Public Meeting on Reg Guide 1.9 Rev. 5

Frankie Pimentel, Sr. Project Manager - Engineering and Risk

August 11, 2021

Figure 1
IEEE Std 387-2017

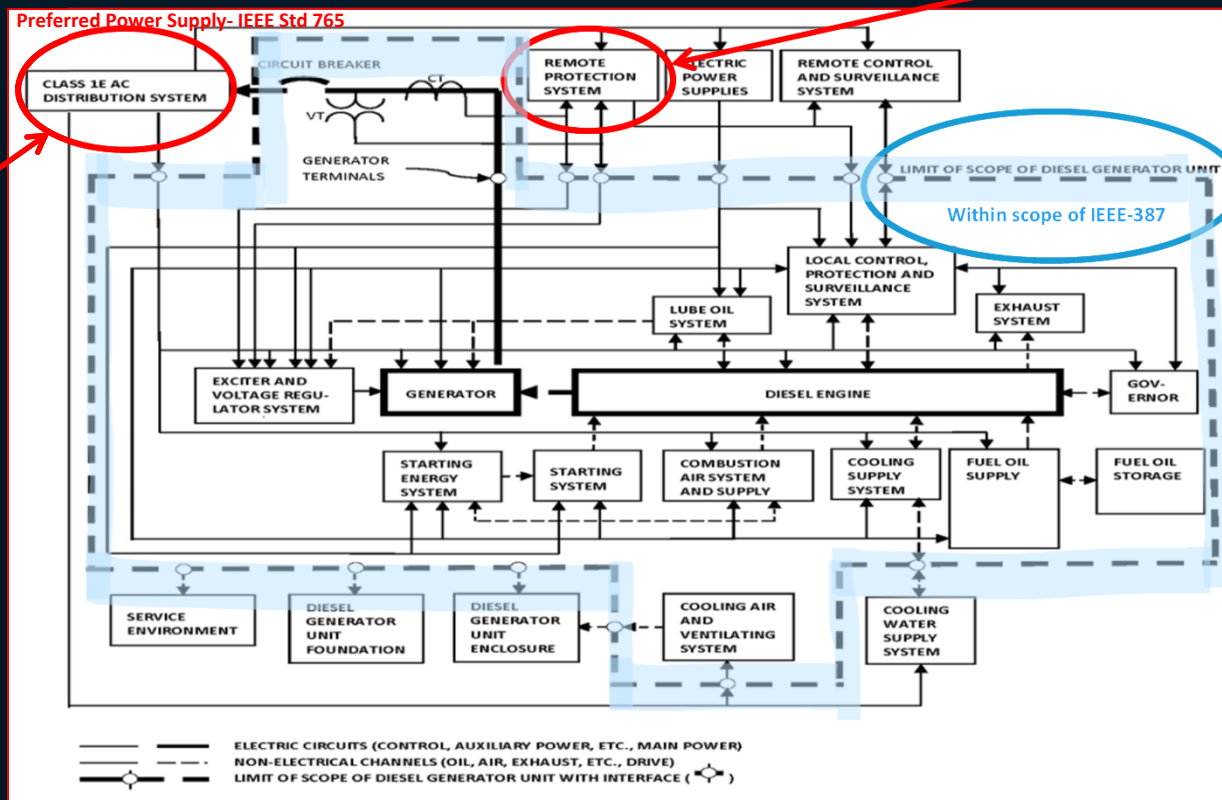
More appropriate to IEEE Std 308 and IEEE Std 741

More appropriate to IEEE Std 308

- Any **design** associated with the detection and protection from a degraded ***preferred power supply*** should be considered part of the “*Remote Protection System*” per Figure 1 of IEEE Std 387-2017 and as such is outside the scope of IEEE Std 387

- The appropriate standards for “*Remote Protection System*” would be IEEE Std 308 and IEEE Std 741
 - The appropriate standard for the ***preferred power supply*** would be IEEE Std 765

- The EDG responding to an accident, loss of offsite power, or both (**signal**) while the EDG is in test mode and paralleled to the grid, is an example of a protection signal that originates **outside** of the EDG scope “*Remote Protection System*” per Figure 1

- IEEE Std 387-2017 principal design criteria is to ensure that the design of the EDG will respond to a valid external signal, but it is not within the scope of IEEE 387 to design these **Remote Protection Systems**

- Remove the proposed addition of Position C.2.3 to supplement IEEE Std 387-2017, Clause 4.4, Table 1
